ADMINISTRATIVE APPLICATION CHECKLIST

[D] Other: Specify: AMEND SWD-1420 BASED ON APPLICANT SUBMITTAL

OXY
API-30-025-26976
NBR Well #1
SWD-1420-A

From: Goetze, Phillip, EMNRD
Sent: Tuesday, July 23, 2013 2:56 PM
To: 'David_Stewart@oxy.com'
Cc: Joseph_Michael@oxy.com; Gonzales, Elidio L, EMNRD; Kautz, Paul, EMNRD; Ezeanyim, Richard, EMNRD
Subject: RE: OXY USA Inc. - NBR #1 SWD - 30-025-26976 - Recompletion to SWD

**RADIAL BOND
GAMMA-RAY / CCL
LOG**

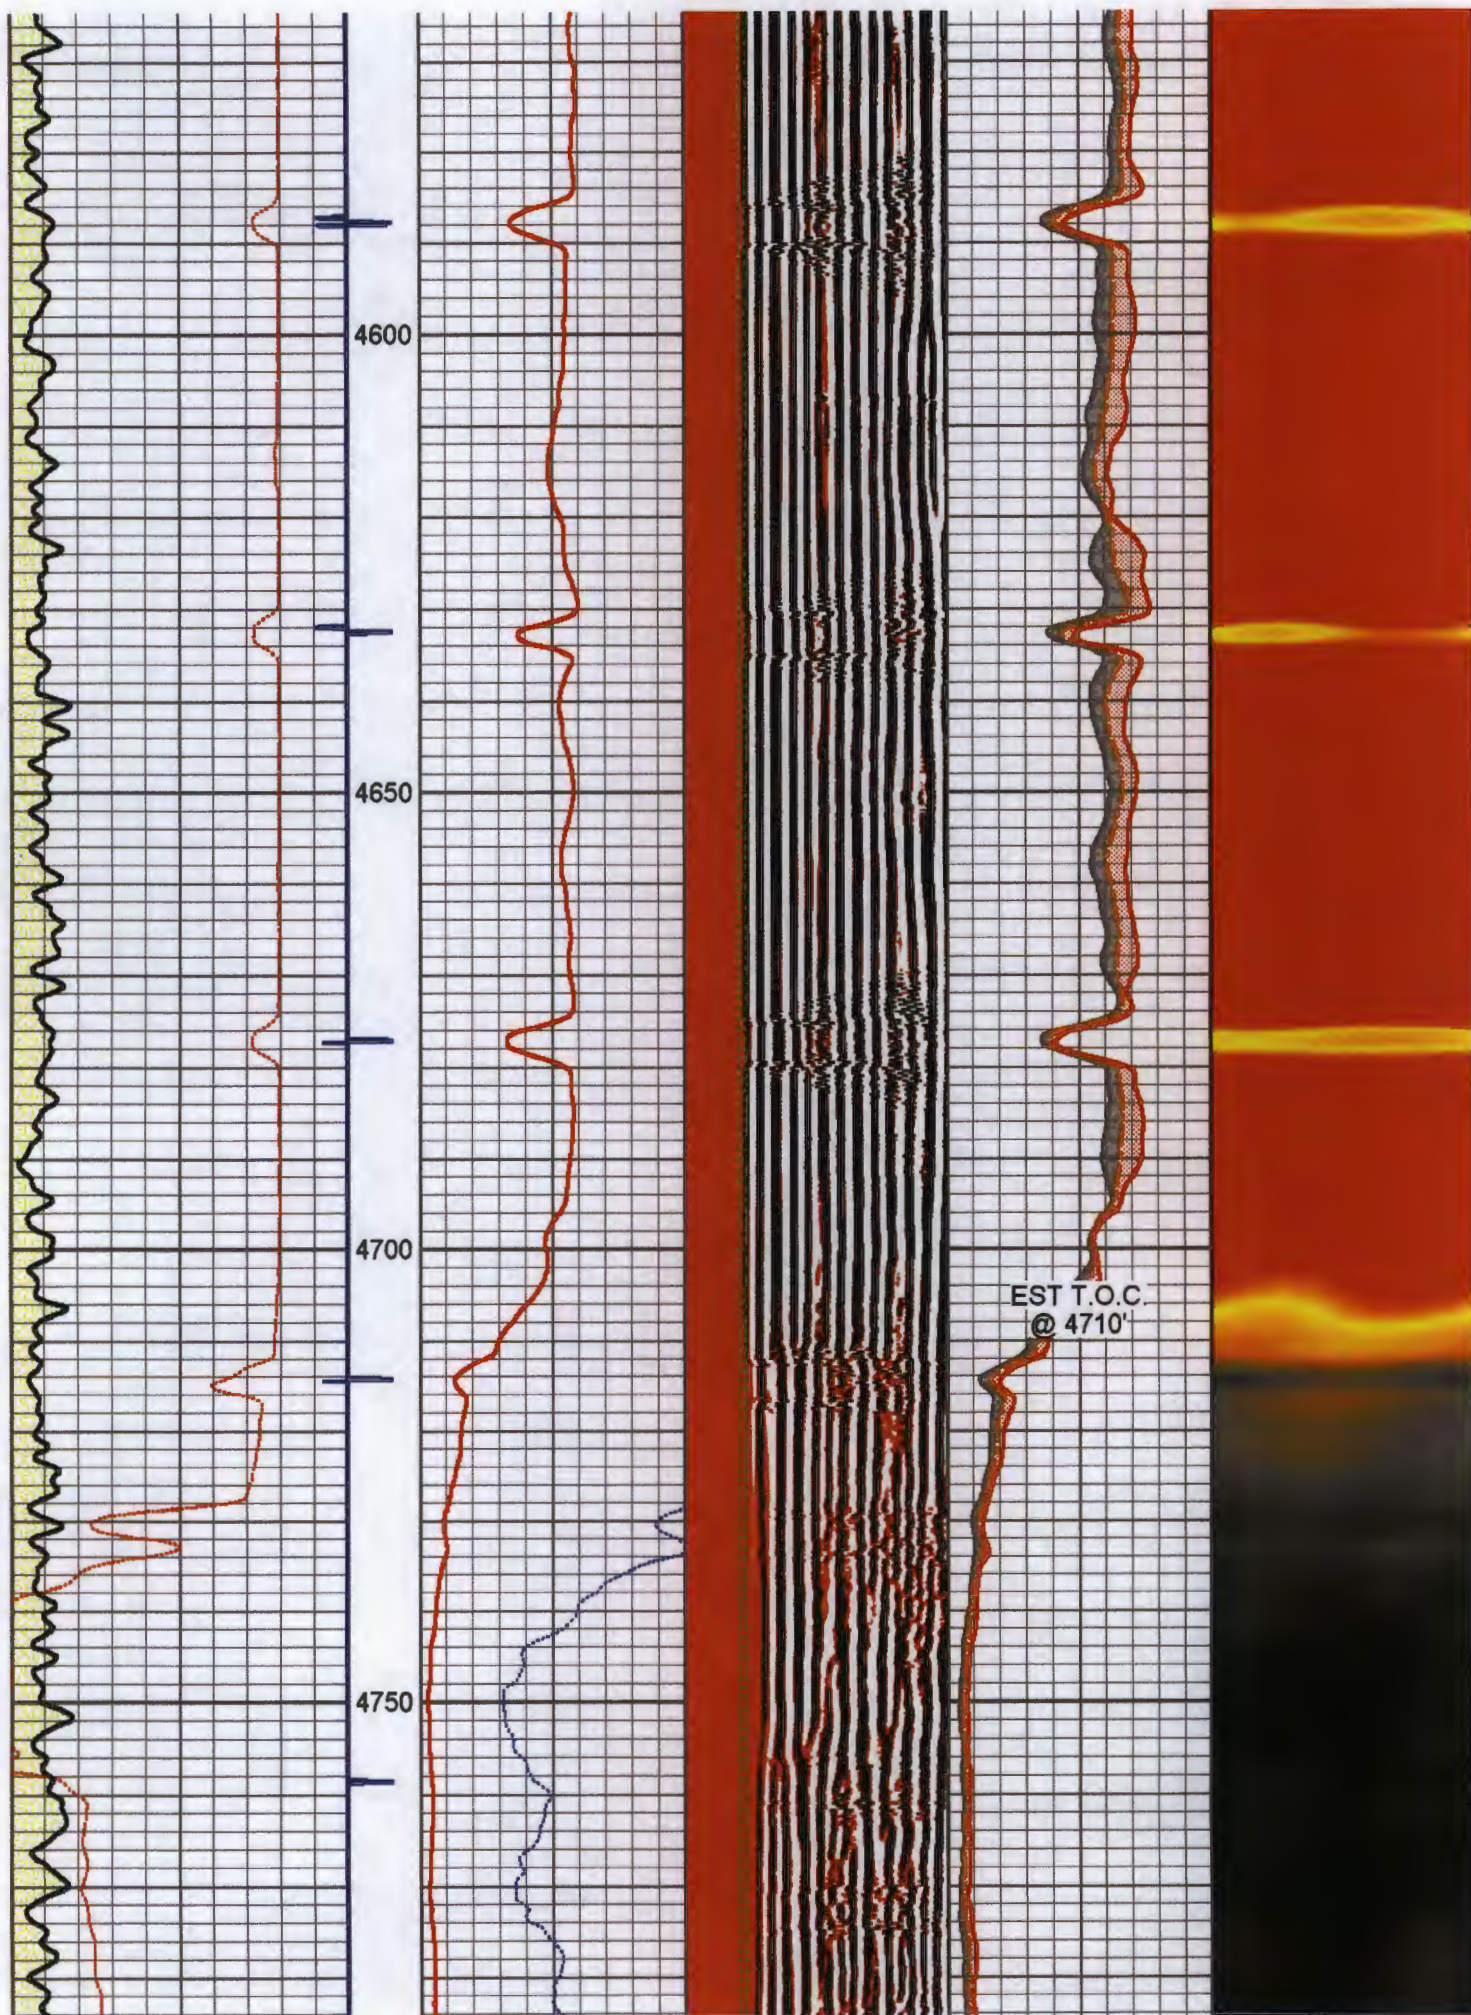
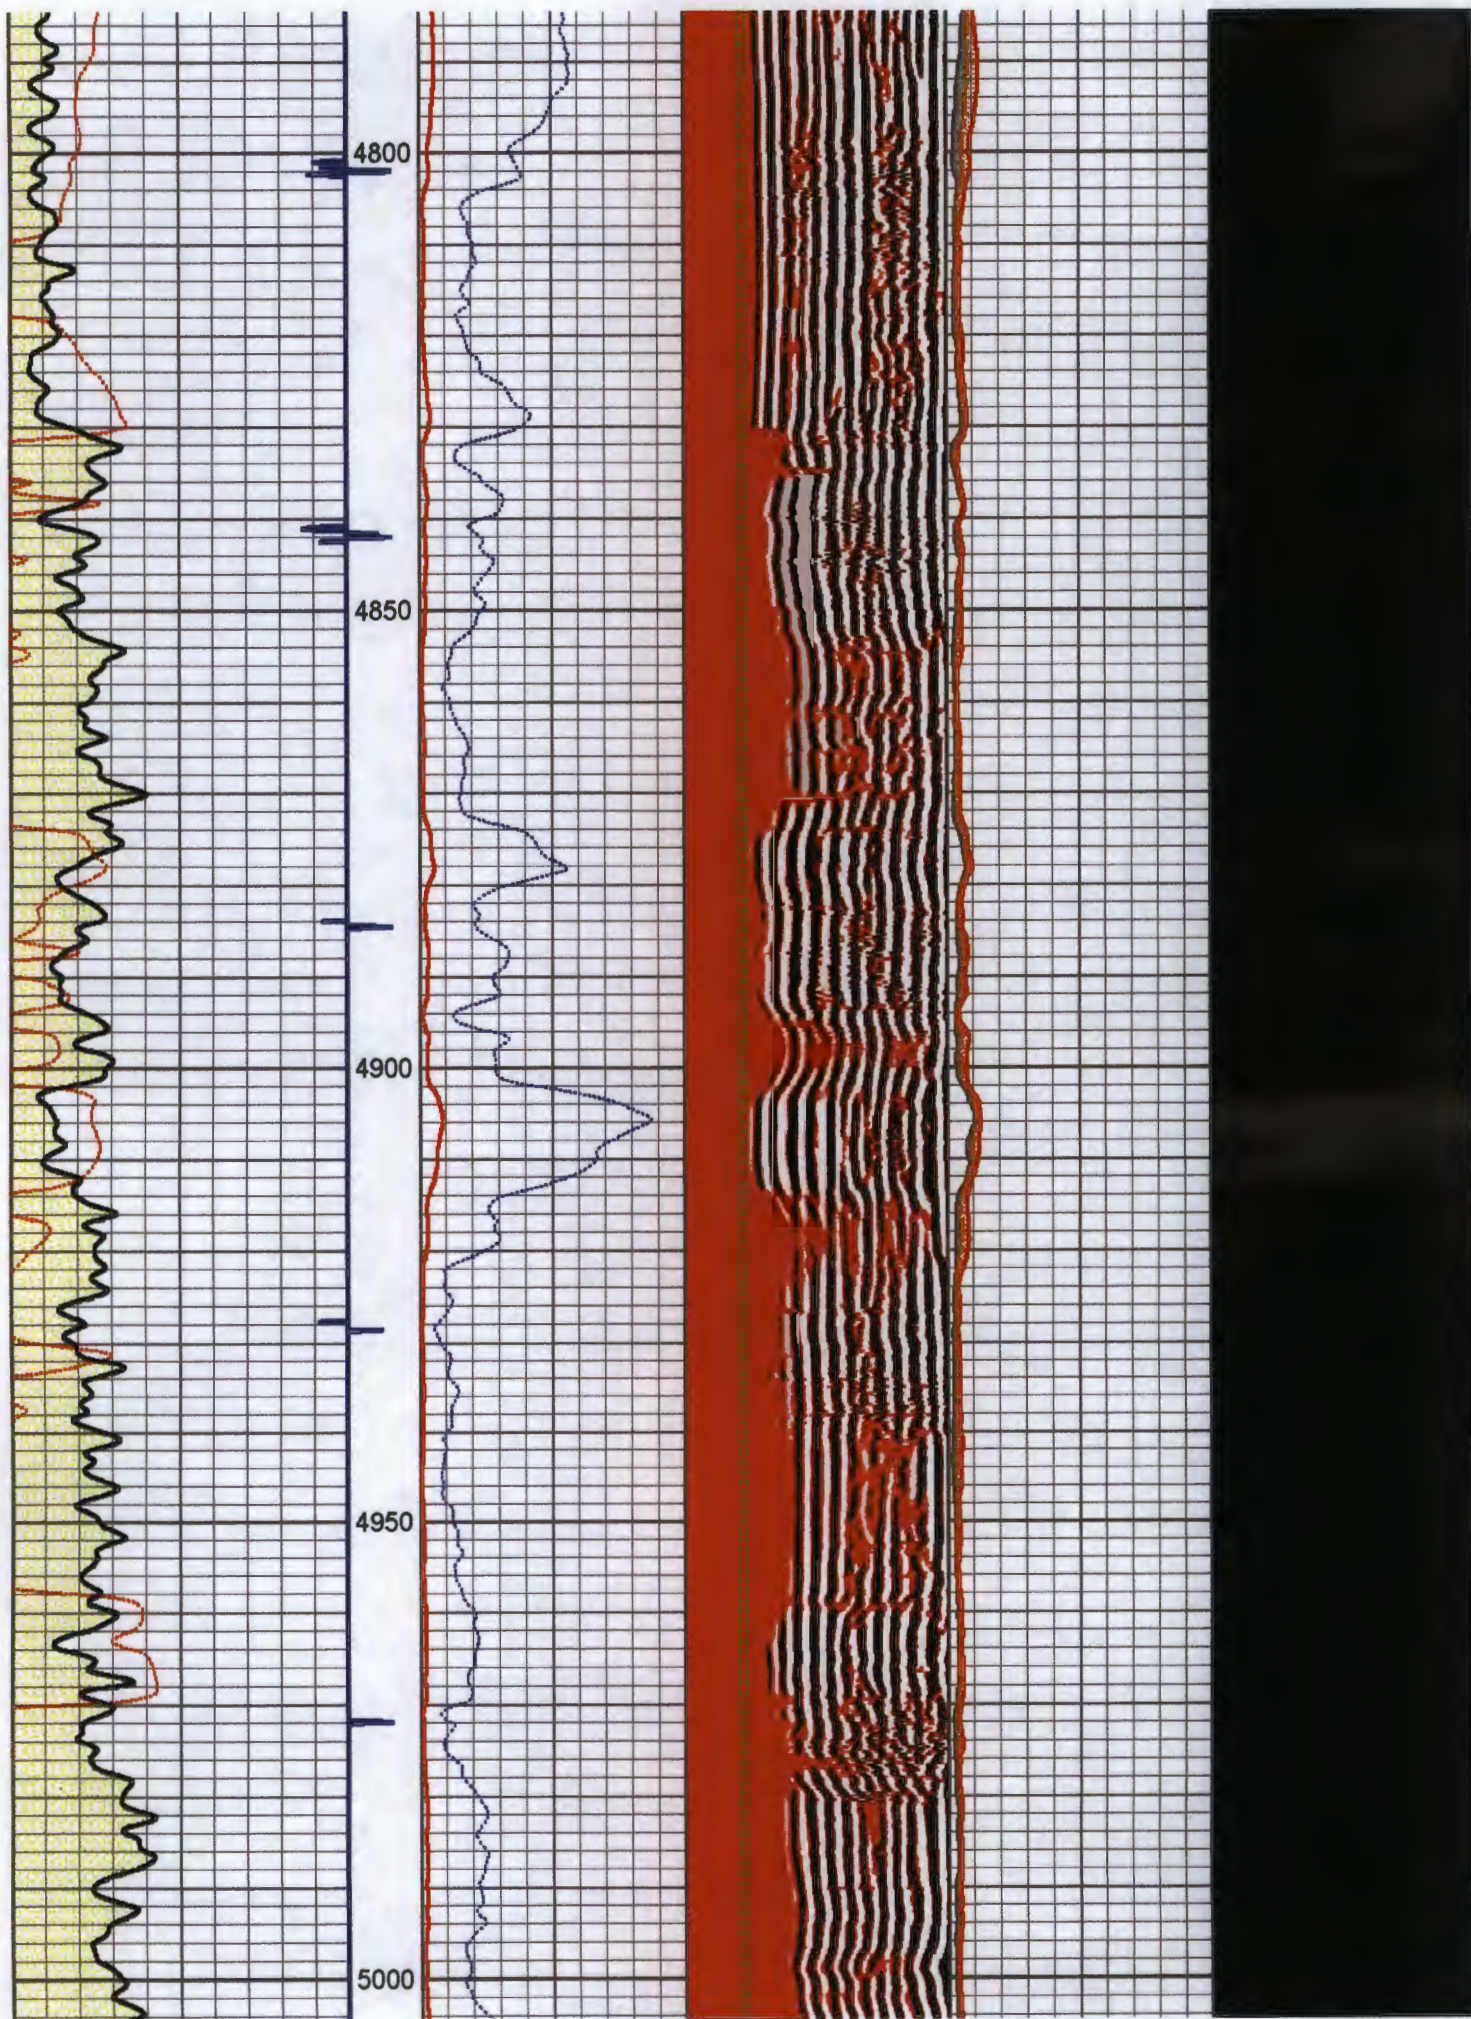
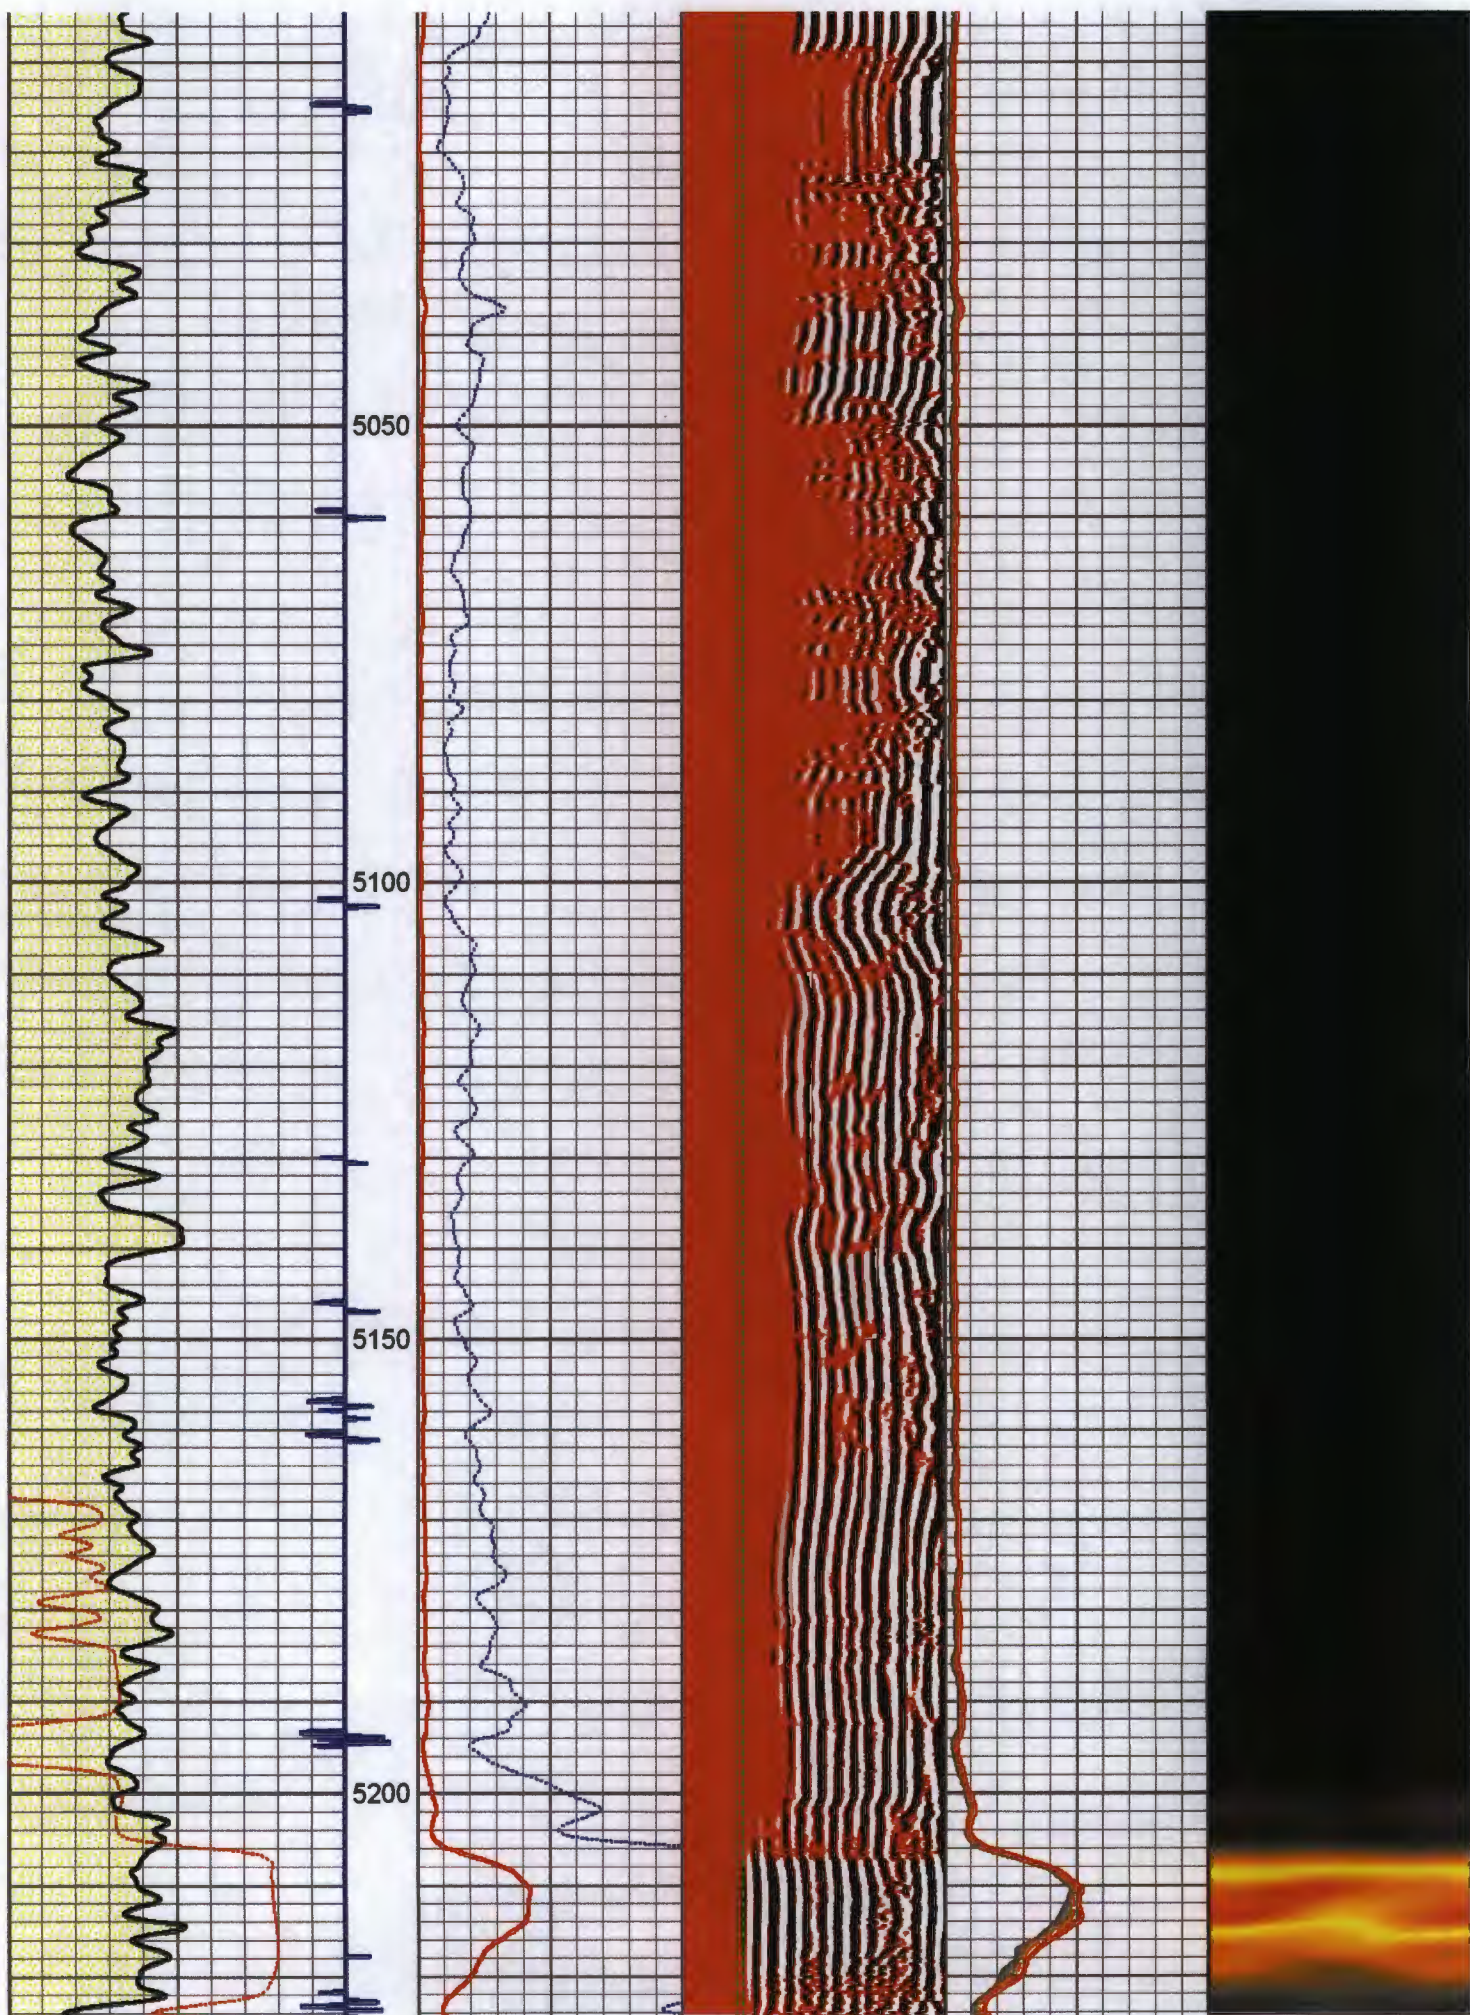
OXY has completed the plugback portion of the recompletion on our NBR #1 (30-025-26976) conversion to SWD. After we perforated and squeezed the 7-5/8" casing @ 5220' w/ 220sx cmt, a CBL was ran and shows the TOC @ 4710'. The SWD permit was approved for a top perf @ 4952', but OXY plans on the top perforation to be @ 5018'. Before we continue to complete the well, we would like to know if the TOC @ 4710' will be sufficient with the top perf @ 5018'. We are concerned about perforating the casing again to attempt to bring the cement up to 4500' as was originally proposed.

As mentioned on the phone, after reviewing the CBL, we TOC at 4,700'. For us to meet state regulation of 500' above top perf we would have to go back and do another cement squeeze. We want to perf between 5,018' – 5,280' as this is the best zone to inject into. The risk in doing that, is that we could potential perforate through 2 casing strings and if the cement squeeze isn't successful, we could create more damage by opening up a channel to contaminate fresh water.

The CBL shows that we have 300' of very good cement and should provide adequate isolation. Also above the Bell Canyon we have 100' of the Lamar which is a limestone and an Anhydrite zone, those 2 zones can also act as a barrier and will stop the frac from propagating upwards.

The package of information and the proposed changes in well construction have been reviewed with the Artesia District and with Richard Ezeanyim of the Engineering Bureau. It is OCD's opinion that the current TOC of 4710 ft for the 7 7/8-inch casing along with top perf being lowered to the proposed 5018 ft depth is sufficient to satisfy the requirements of the SWD permit. I will go and amend the existing permit to reflect the change in the top perf location and that the final TOC is acceptable.

You need to be aware: 1. that the packer will have to be located no shallower than 4918 ft based on the new shallow perf depth and 2. that the max surface inject pressure will increase to 1004 psi. Also, I need a clarification on the injection interval; you noted a lower perf of 5280 while the proposed C-108 completion showed 5998 ft for the lowest perf. Since I am amending the permit, what is going to be final interval, considering the planned life of the SWD well? Please provide some information regarding the last item. Thanks. PRG
